**21-COA-0022**  
**236 Albany Ave.**

**Clifton Architectural Review Committee**  
**Public Hearing**

**Bradley Fister, Historic Preservation Specialist**  
**February 24, 2021**

## Certificate of Appropriateness:

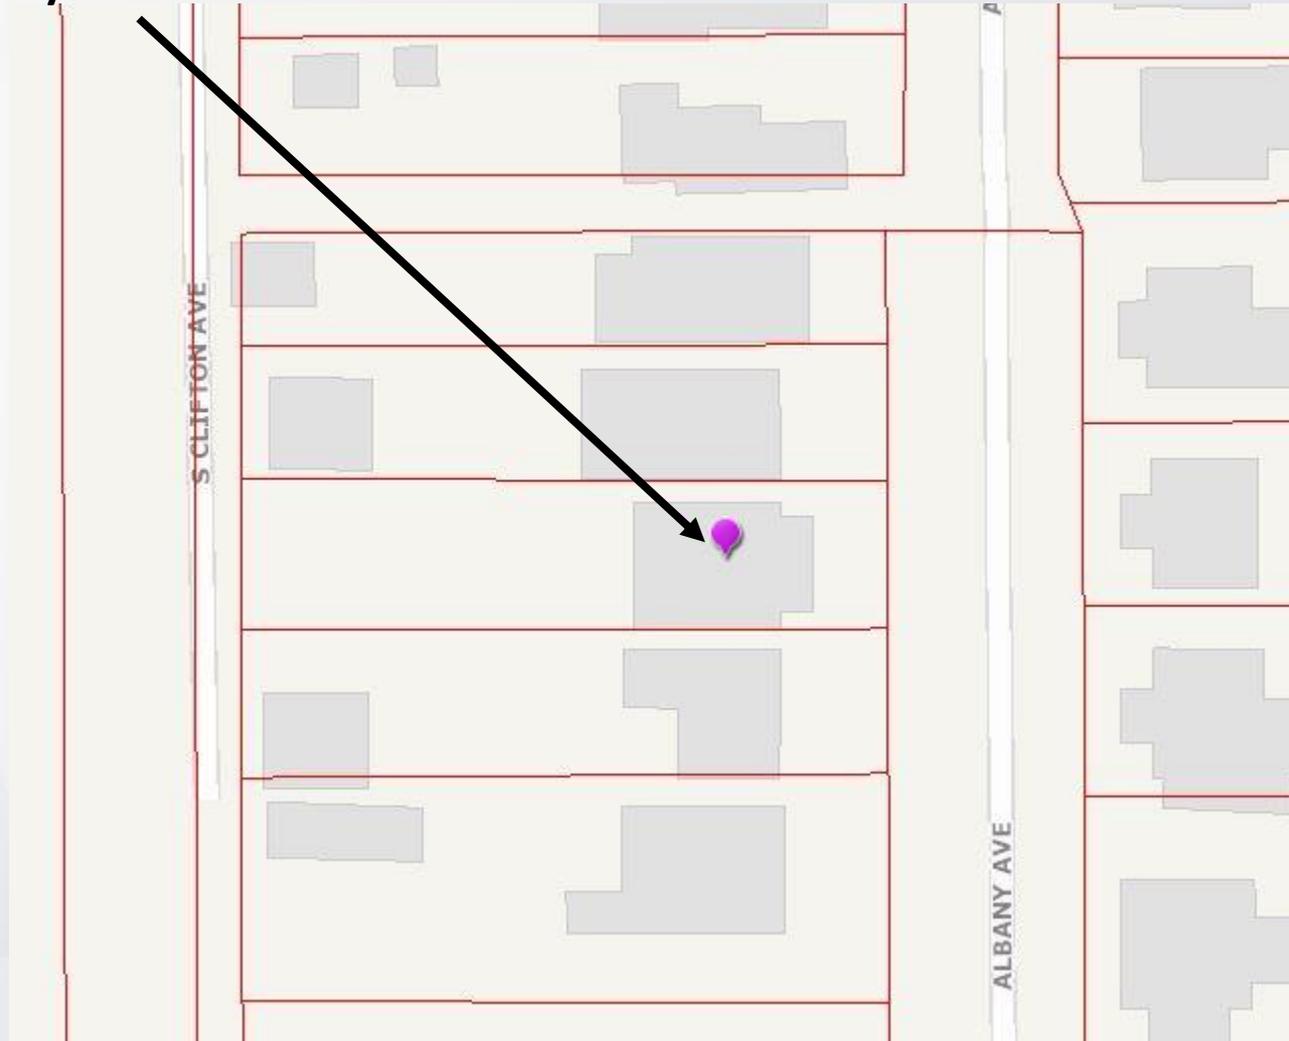
north and south elevations show asphalt shingles on an approximately 8:12 pitch front facing gabled roof, aluminum gutters, and one small clerestory window on both sides; on the west elevation one 16' W double garage door facing the alley along with a window in the gable; on the east elevation an approximately 36" W person door with an adjacent double-hung window and a double-hung window in the gable as well.

- The walls will be concrete block with (TBD siding in gables), and there are multiple concrete block structures in the vicinity. The design is simple, in scale with surrounding structures, and is appropriate for the Clifton Historic District. The design however does not comply with **G-11**, as it is concrete block that has not been skim coated or parged.

- It also does not meet the preference for single-car garage doors per **G-14**. The applicant proposes the use of a double-car door due to the narrow alley and size of vehicles to make turn into garage. The applicant proposes to use a carriage style door, that visually articulates two single-car garage doors.

- On the basis of the information furnished by the applicant, staff recommends a Certificate of Appropriateness be approved with the following conditions:
  1. The concrete block shall have a flush joint finish and be painted with a breathable masonry paint, or the concrete block shall be skim coated /parged and then painted.

2. The siding shall have a 3” or 4” reveal depth, and material choice submitted to staff for approval prior to instillation.
3. The applicant shall install a carriage style door that visually articulates as two single-car garage doors, door shall be submitted to staff for approval prior to being installed.
